INDIANA DEPARTMENT OF TRANSPORTATION
Driving Indiana's Economic Growth

September 20, 2012 Standards Committee Meeting

RE: Agenda for the September 20, 2012 Standards Committee Meeting

Figure 404-4D

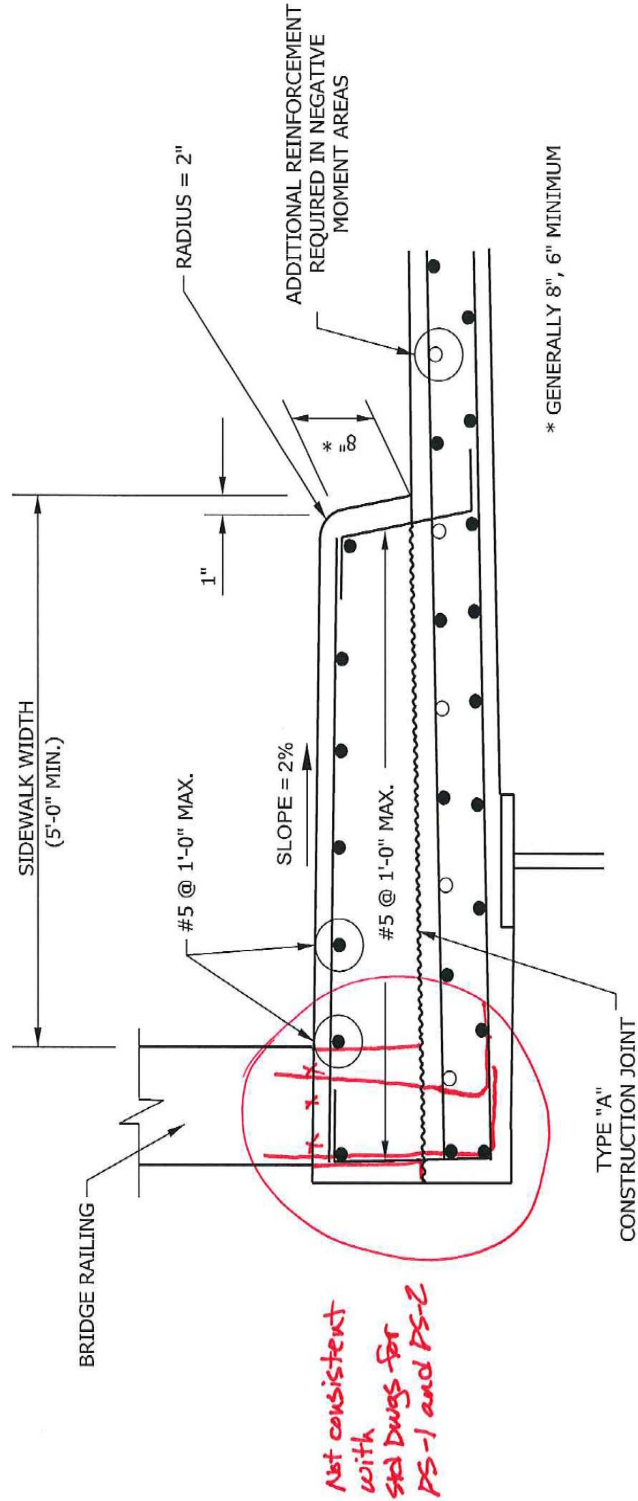
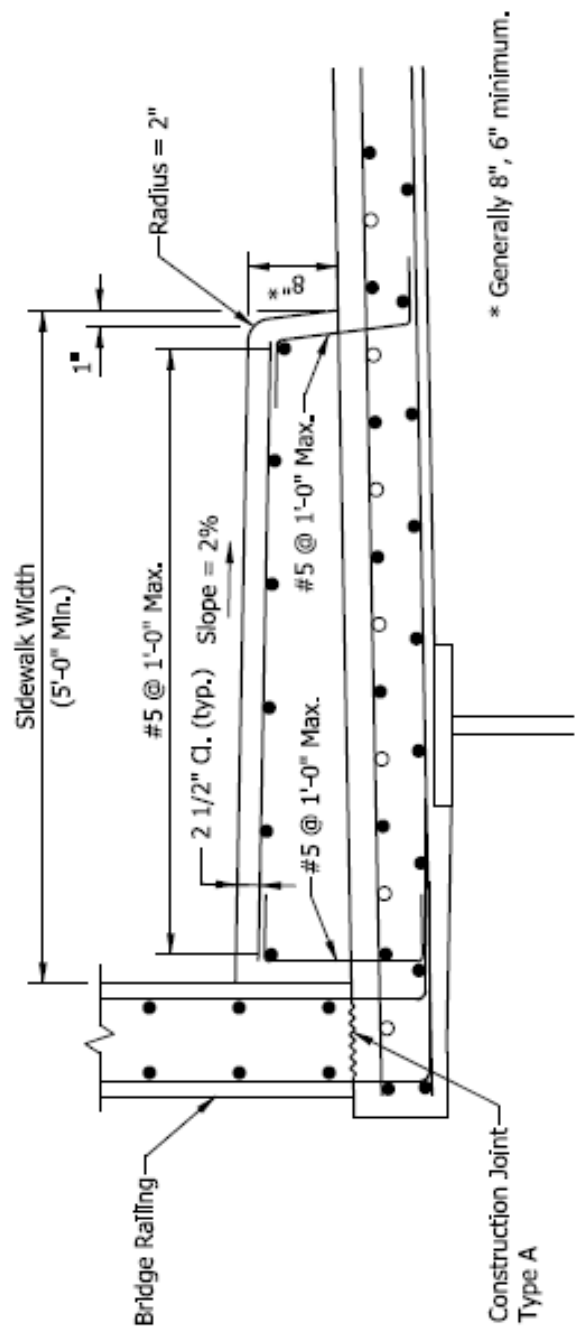
PROBLEM(S) ENCOUNTERED: With the publication of corrected Standard Drawings 706-BRPP-03 and -04, the bridge railing construction shown in Design Manual Figure 404-4D is no longer consistent with the Standard Drawings for pedestrian bridge rail in combination with a concrete sidewalk. The concrete bridge rail should not be shown sitting atop the sidewalk.

PROPOSED SOLUTION: Revise the Design Manual Figure 404-4D for consistency with the pedestrian bridge rail Standard Drawings 706-BRPP-03 and -04. See attached markup and final draft of proposed revised figure.

EXISTING STANDARD DRAWING 802-SNGP-01 SIGN PLACEMENT (WITH MARKUPS)

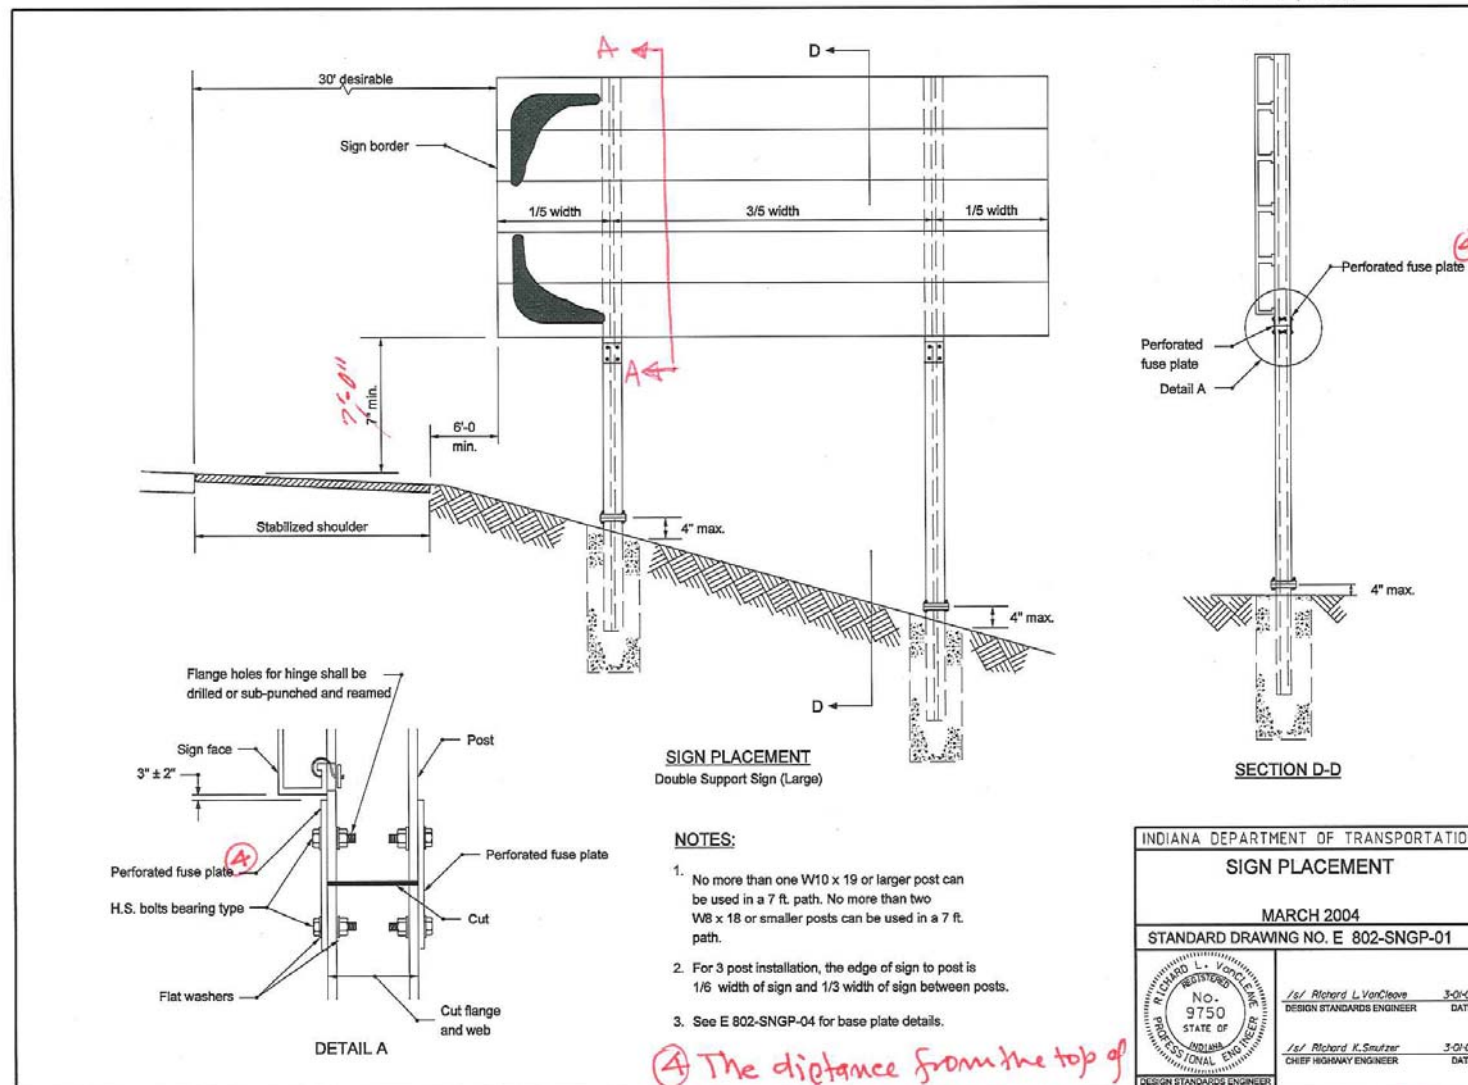
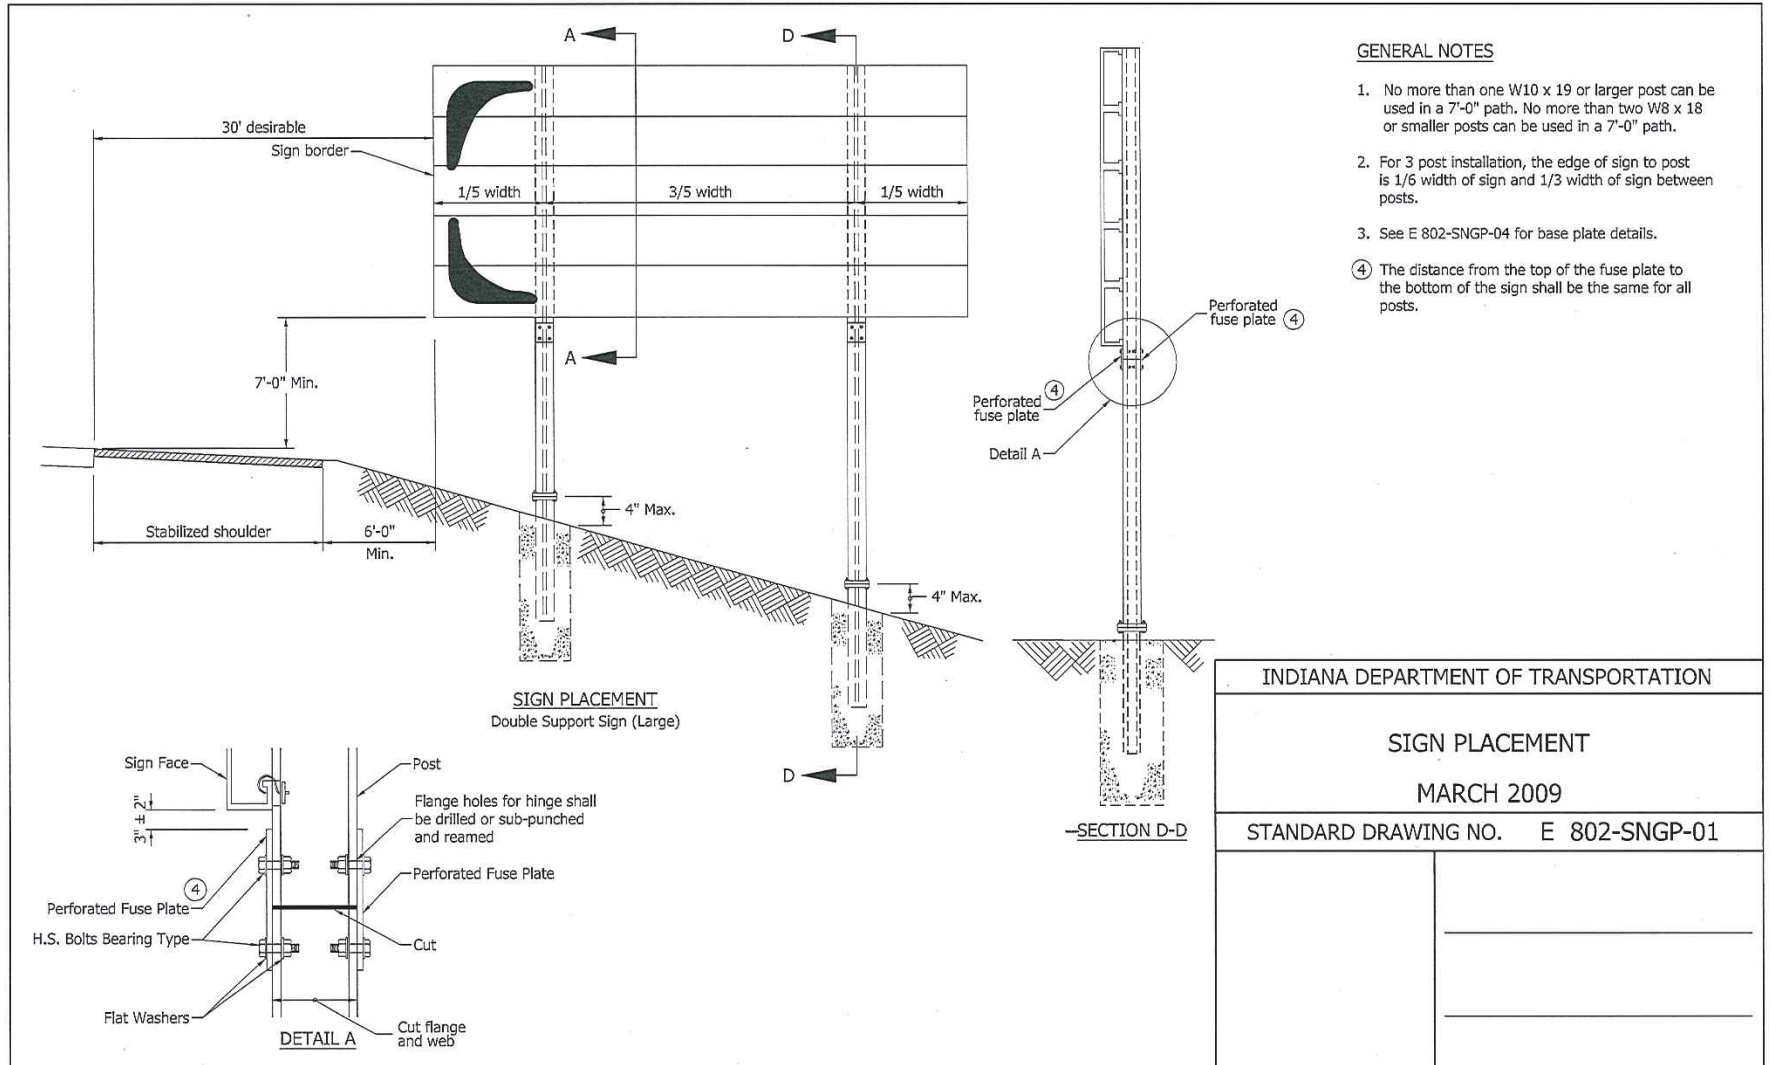
1. On panel sign assemblies the distance between the bottom of the panel sign and the top of the fuse plate often varies from one post to the other in the same assembly. This may lead to the breakaway mechanism not functioning correctly.
2. Clips that attach the sign panel to the support I-beams are not being installed on both sides of the I-beam for signs wider than 24' as they should be. This makes it more likely that the sign will separate from the supports.
3. Standard Drawing 805-SGSP-04 for signal strain poles contains incorrect dimensions for the base plate thickness and anchor bolt hole diameter.

1. Add a note to Standard drawing 802-SNGP-01 that "The distance from top of the fuse plate to the bottom of the sign shall be the same for all posts"
2. Revise Standard drawing 802-SNGP-03 to indicate that clips on both the left side and right side of the posts are required for signs wider than 24'.
3. Revise Standard drawing 805-SGSP-04 by correcting the anchor bolt hole diameter to 2 1/2" (currently shown as 2") and the base plate thickness to 2 1/2" (also currently shown as 2").

④ The distance from the top of the fuse plate to the bottom of the sign shall be the same for all posts.

EXISTING STANDARD DRAWING E 706-TTFC-01 CONCRETE BRIDGE RAILING (WITH MARKUPS)

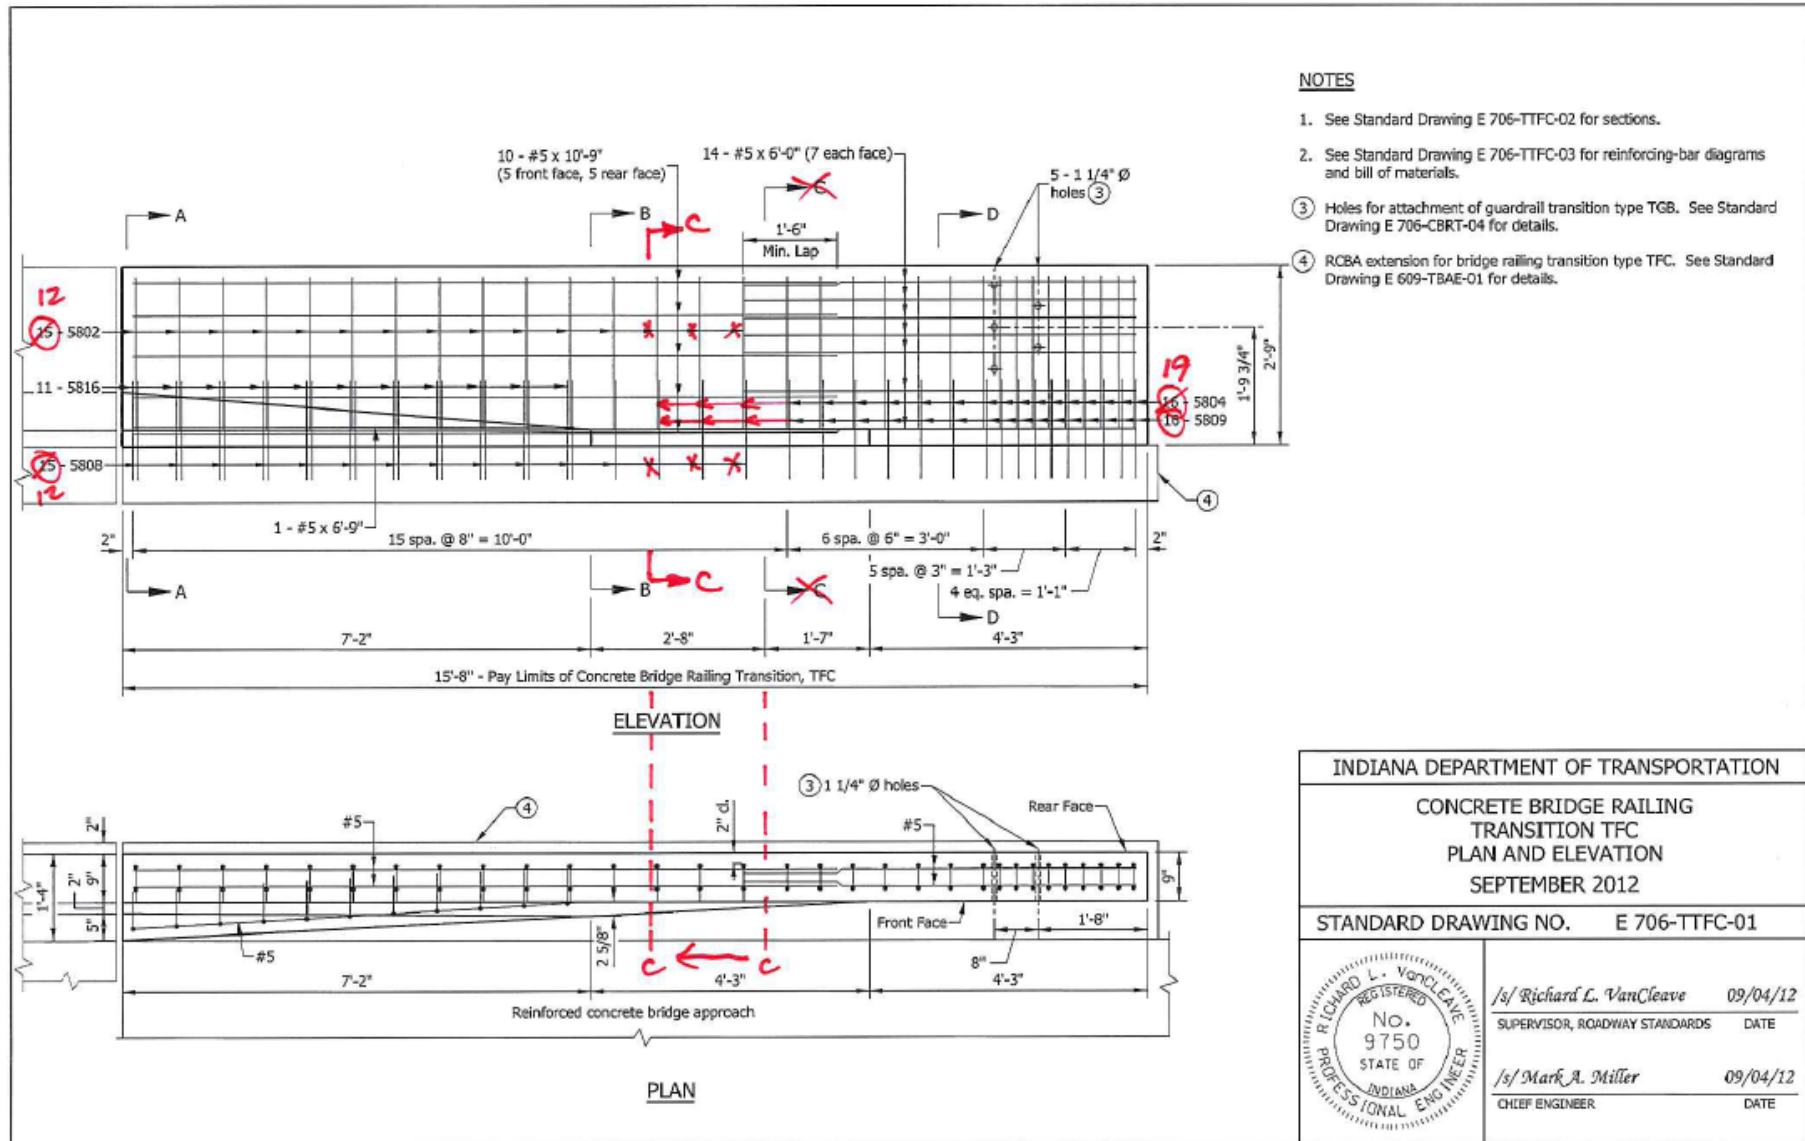
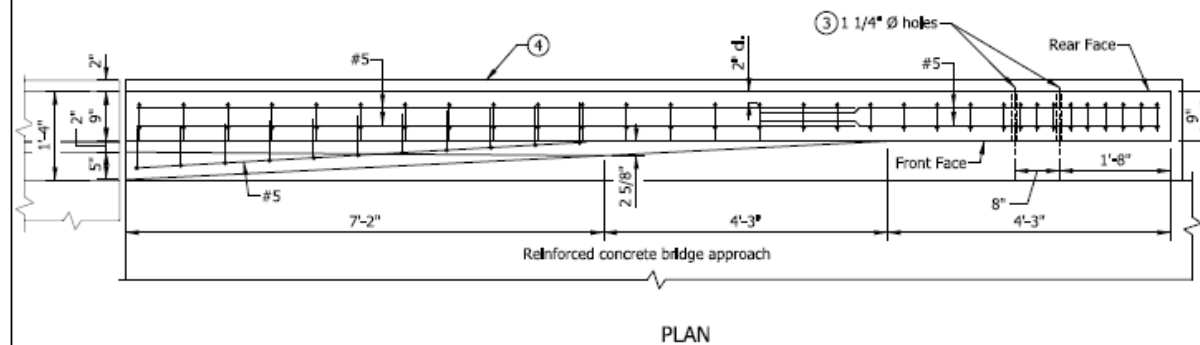
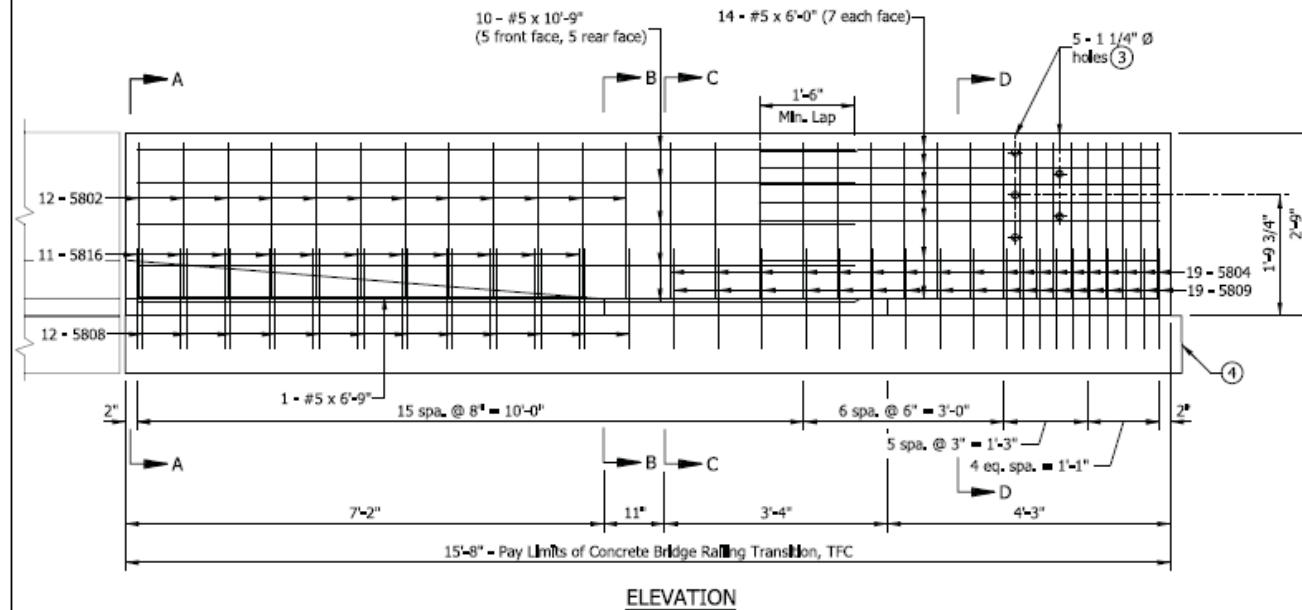
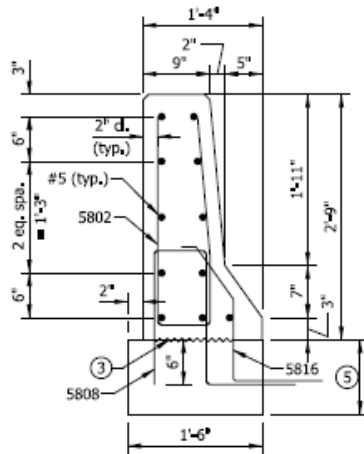
PROBLEM(S) ENCOUNTERED: A review of Standard Drawing 706-TTFC-01 through -03 revealed an error in the location of a section and consequently, an incorrect bill of materials.

PROPOSED SOLUTION: Revise the drawings to show the correct location of the section and quantities in the bill of materials. See attached markups and final drafts of proposed revised drawings.
